Addendum D2

re: **City of Berne**
New Municipal Maintenance Building
335003.00

date: **February 16, 2024**

ADDENDUM NO. 2
To the Contract Document for the

C401

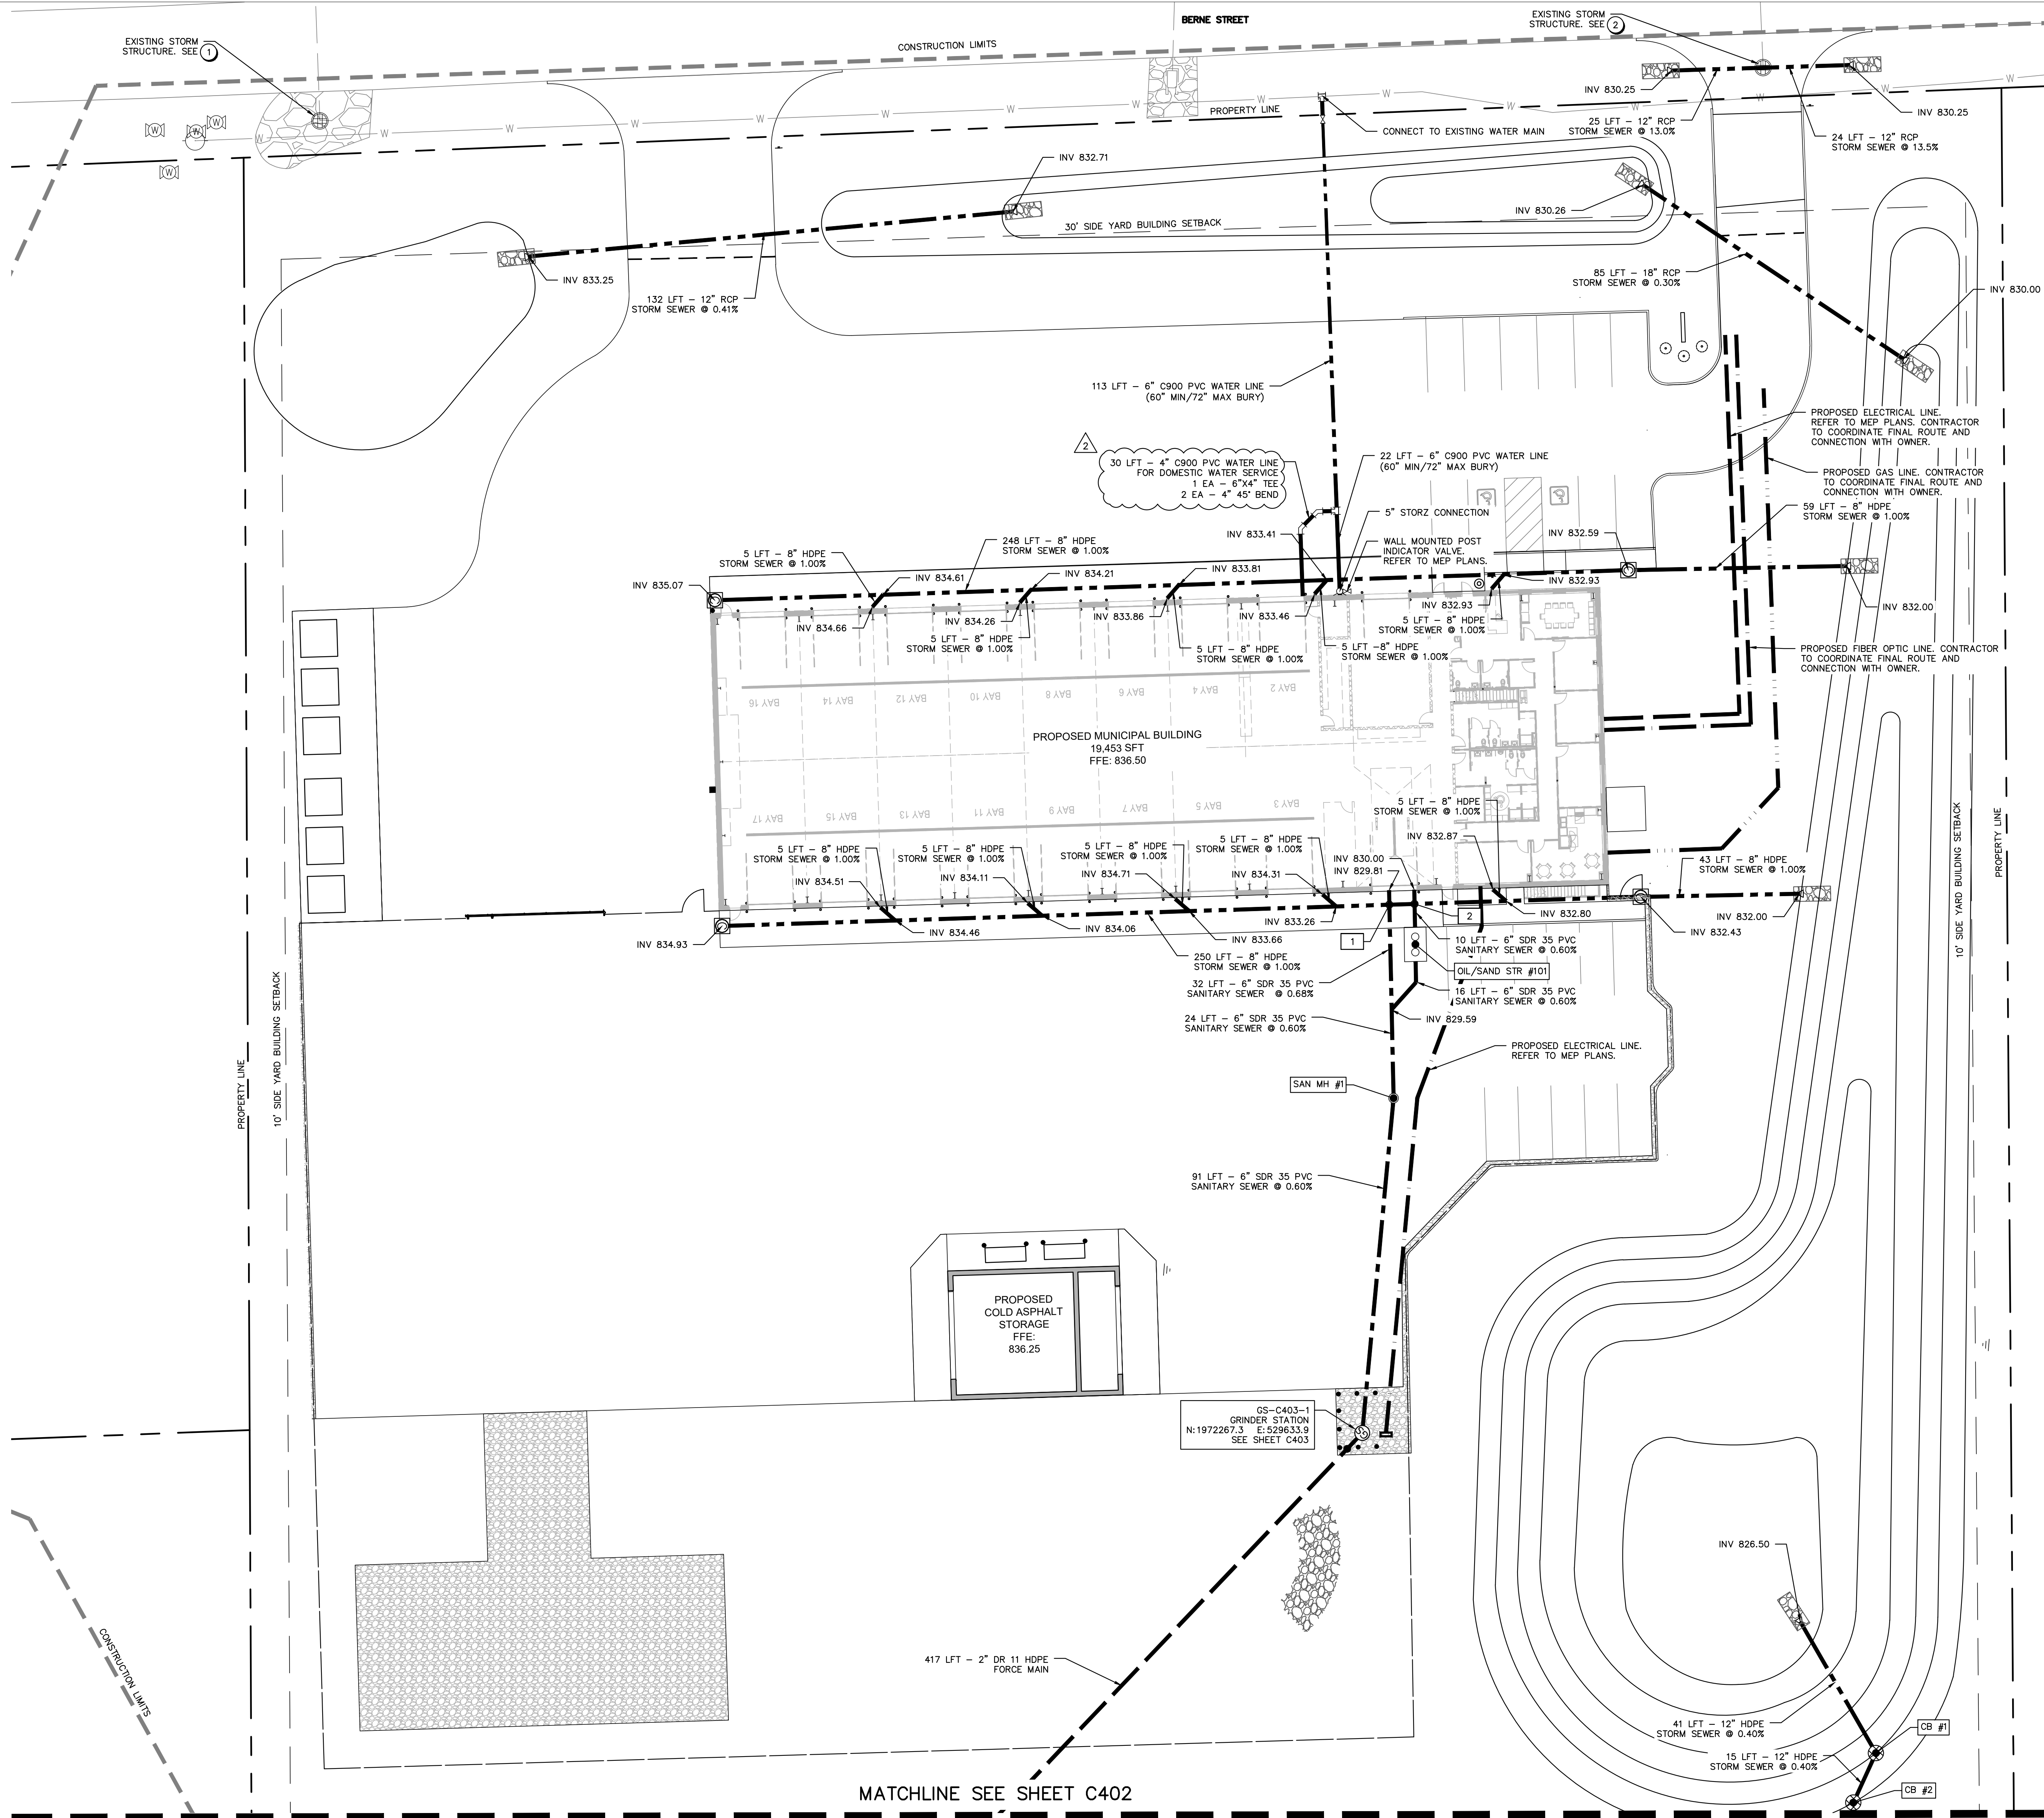
4. Plan Sheet C401:
 - A. **REVISE** 3" water line size to 4" water line
5. Plan Sheet C501
 - A. **ADD** a check dam south of the grinder station.
6. Plan Sheet C502

C502

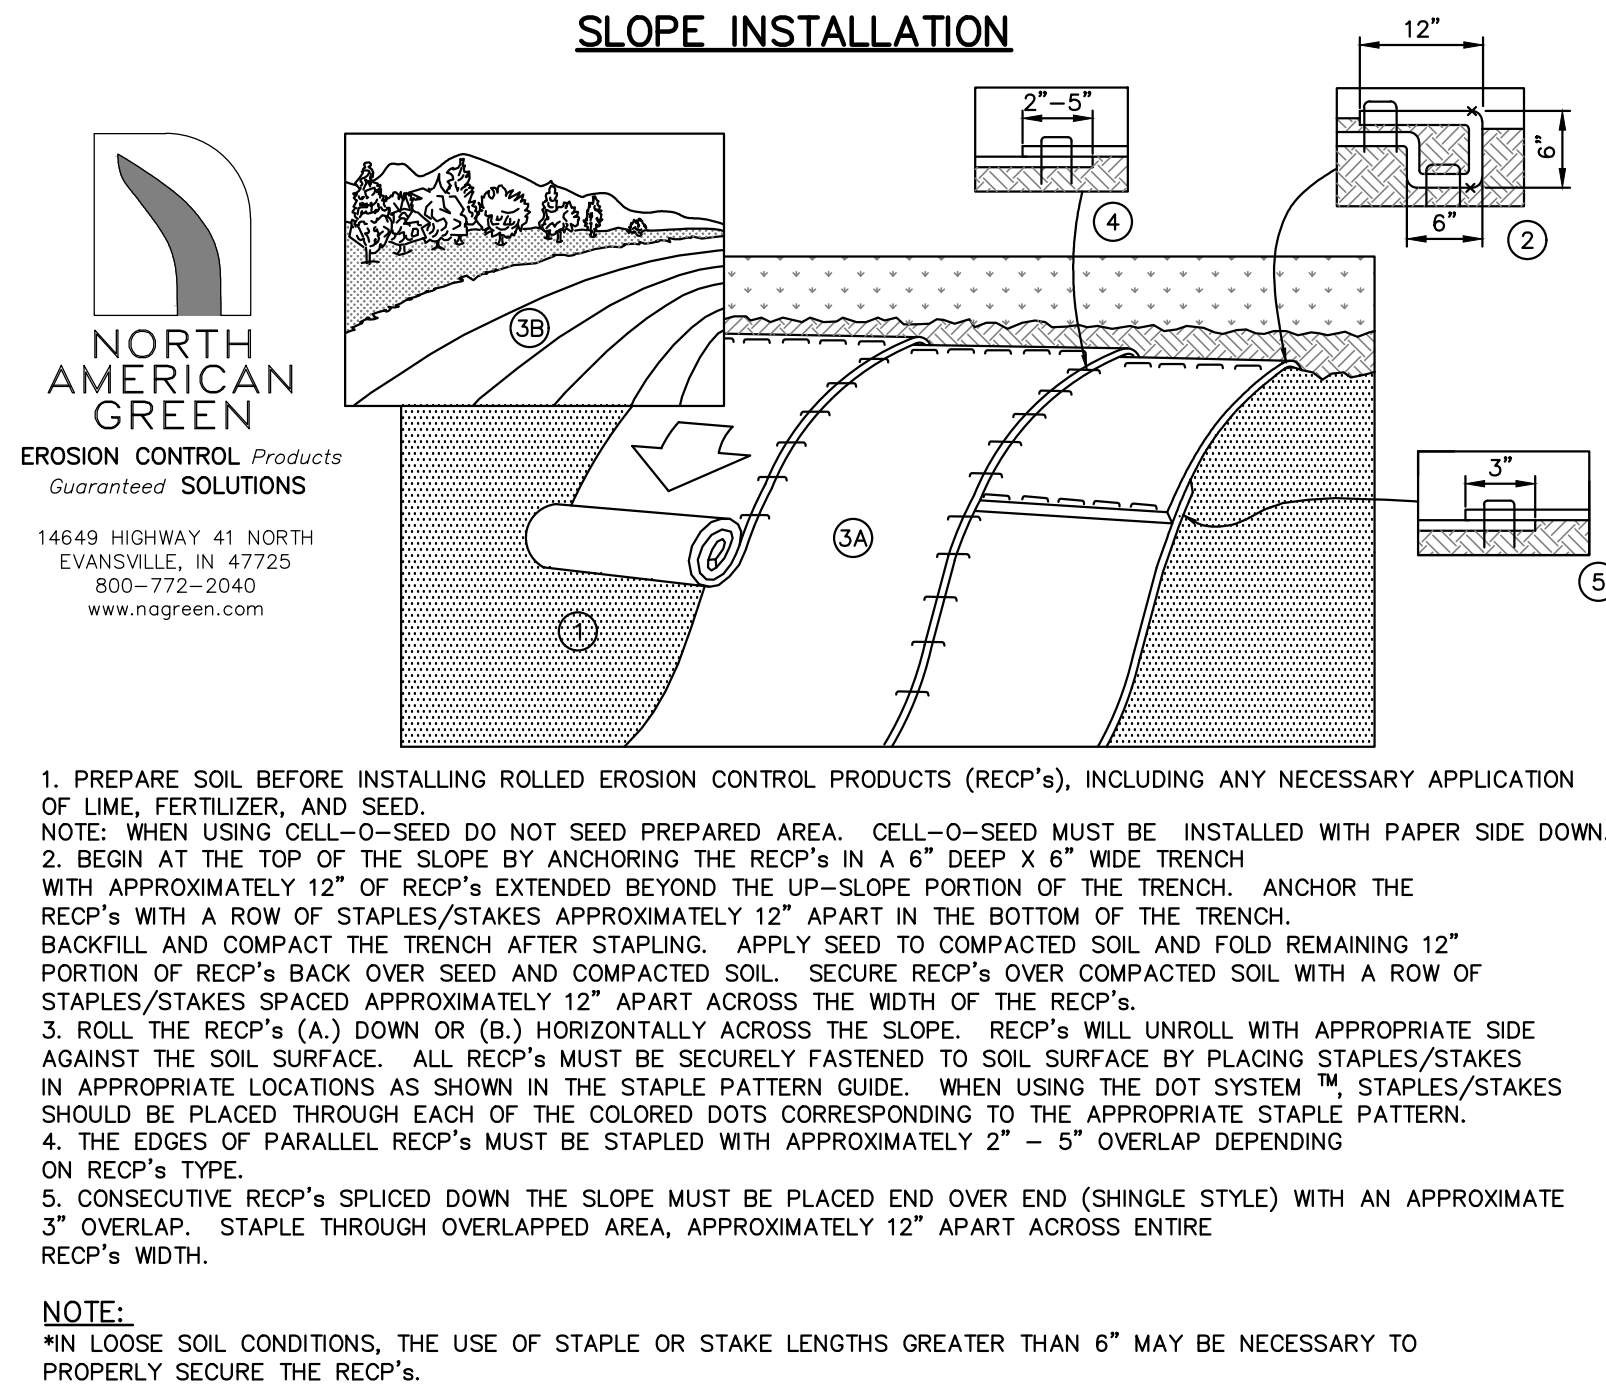
- A. **REVISE** grades.
7. Plan Sheet C503
 - A. **ADD** Detail 11 for check dam.
8. Plan Sheet C601
 - A. **REVISE** seeding limits on the south end of the site.
